# Preferred Project Report

## Former Hoxton Park Aerodrome

Concept Plan & Concurrent Project Applications for the  
Construction of Warehousing and Distribution Facilities for  
Woolworths Limited

MP10\_0007 through to MP10\_0010

**Figure 1** – Revised Concept Plan and Stage 1 Infrastructure Project Application Boundary (for site subdivision)

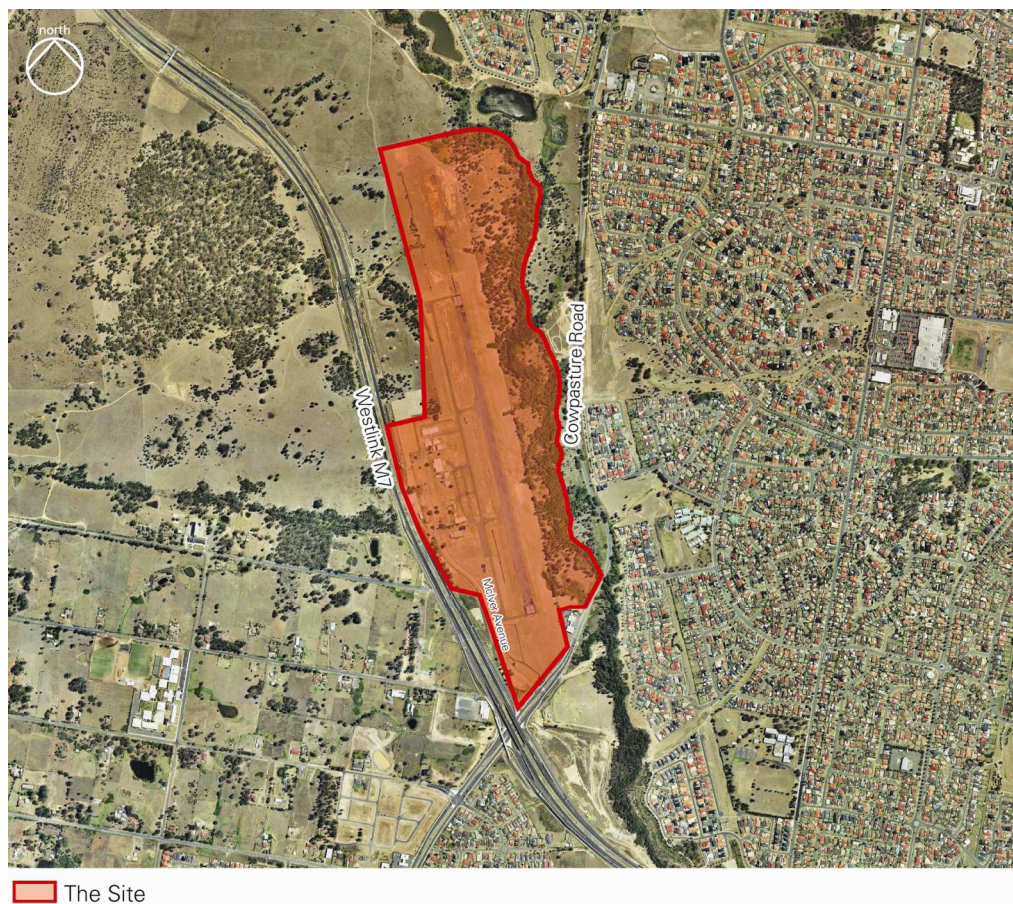
It has come to our attention that last minute changes which were made to the boundary of the site has meant that the not all of the land covered by the proposed subdivision of the site is included in the site boundary of the application. As such, it is proposed to amend the site boundary such that it covers all of the land affected by the proposed subdivision. The revised site area is shown in **Figure 1** below. We note that the new areas included in the revised site boundary are only proposed for the purposes of site subdivision and will not involve any physical works under this application.
